Attached are my recommendations on the dumping at sea application for Ballycotton Harbour.

RE: Cork Co Co Ballycotton Dumping at Sea permit application

Date: 12/04/2022

Figure 1. Recommended areas to be excluded from Dumping at Sea permit, indicated by red line —

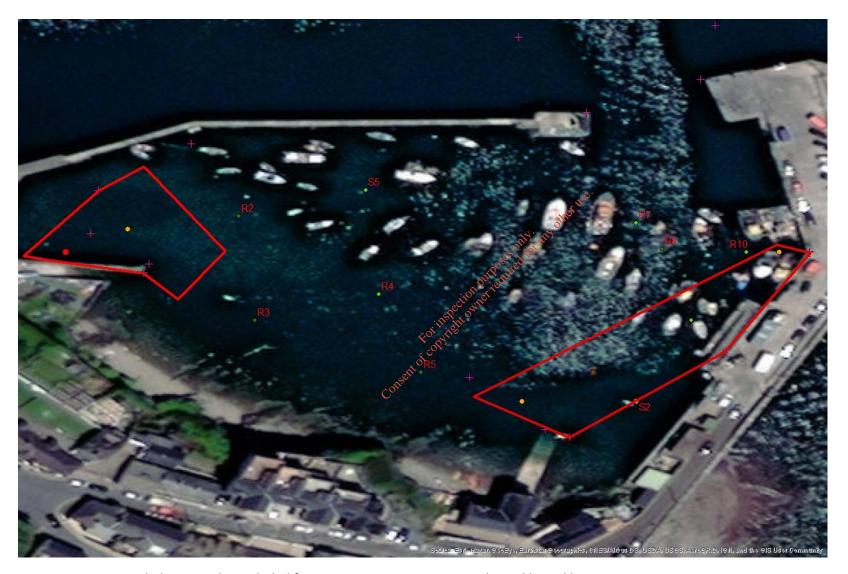
As the contamination appears to be reasonably localised in the west corner and along the east side of the prosed dredging area, it is possible to delineate the contaminated areas. It is recommended that these areas be excluded from dumping at sea. These areas are illustrated in Figure 1, below.

Sediment from the area within the exclusion areas should be treated separately and subjected to alternative management options.
